**Re: Interim Closure and Reclamation Plan – Version 3.2**

## Reasons for Decision

<b>Reference/File Number:</b>	W2018L2-0003
<b>Licensee:</b>	Nighthawk Gold Corp.
<b>Subject:</b>	Version 3.2 of the interim Closure and Reclamation Plan

Figure 1. Map of SNP Stations (Lardass Lake is shown in the bottom (south) of the photo.)

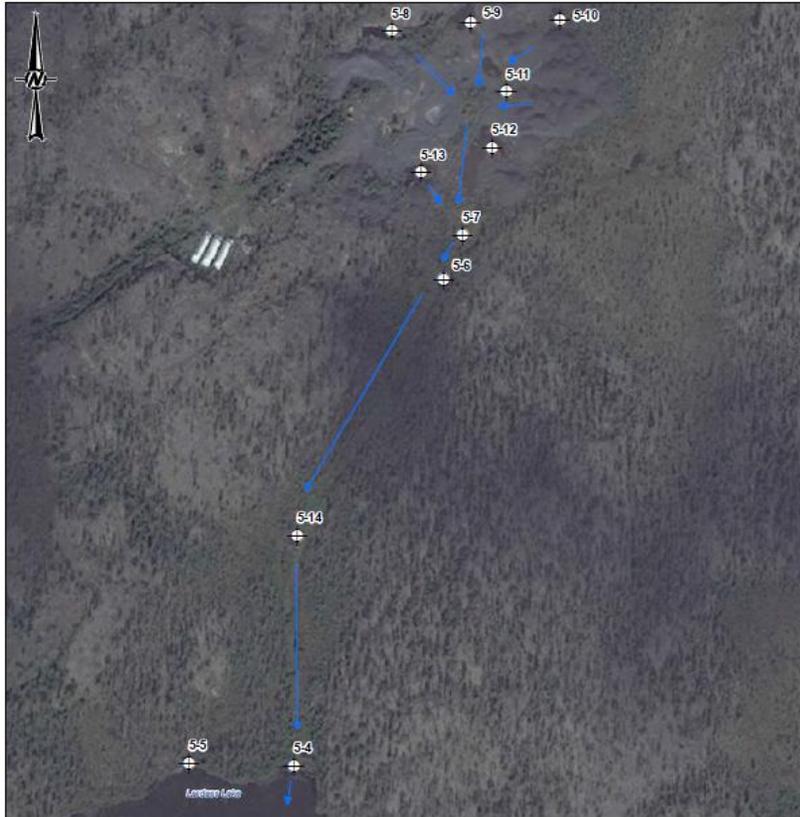
- SNP 5-4: As shown in Figure 1, SNP station 5-4 is where the site drainage enters Lardass lake. At this location, CCME chronic guidelines will not be met for several parameters. Despite this, Nighthawk concluded that closure criteria for Lardass Lake will be met. This was based on a comparison of the CCME chronic guidelines to the predicted concentrations in a fully mixed lake. It is unclear why Nighthawk used the predictions for a fully mixed lake to determine whether closure criteria are met.

- SNP station 5-5: In its response to comments, Nighthawk identifies this location as its preferred location for meeting CCME chronic guidelines (responses to ENR comments 17 and 30, ECCC comment 4, and WLWB staff comment 8). However, it is not clear how much mixing will have occurred at SNP station 5-5 which appears to be approximately 50 meters from where the site drainage enters the lake. Regardless, if criteria were assessed at SNP station 5-5, this would mean that criteria could be met even if there are concentrations above CCME chronic guidelines between the discharge location and SNP station 5-5. Nighthawk provided no rationale for this approach.

Similar to the discussion on where criteria for Lardass Lake should be measured (section 3.2.2 of the Reasons for Decision), the location where criteria for site drainage are assessed is also important. Based on its response to the Board's requirement to clarify this location, Table 2 of interim CRP Version 3.2 appears to propose that site discharge criteria be assessed at SNP station 5-14. This station is partway between the rock piles and the lake (see Figure 1). However, if metals precipitate along the pathway to the lake, concentrations of dissolved metals in the drainage will decrease as water moves down the pathway (see section 3.2.4 of the Reasons for Decision for a discussion on metals precipitation. Dilution from water in the catchment area may also reduce concentrations. Therefore, Nighthawk's proposal to measure site drainage criteria at SNP station 5-14 (partway down the drainage page as shown in Figure 1) may not ensure criteria are met above that station.

- ***Decision #10: Nighthawk is to propose in Version 3.3 of the interim CRP where closure criteria for Lardass Lake must be met, and provide a rationale.***

- ***Decision #12: Nighthawk is to clarify in Version 3.3 of the interim CRP where the criteria for rock pile source waters and site drainage will be measured and provide a rationale.***
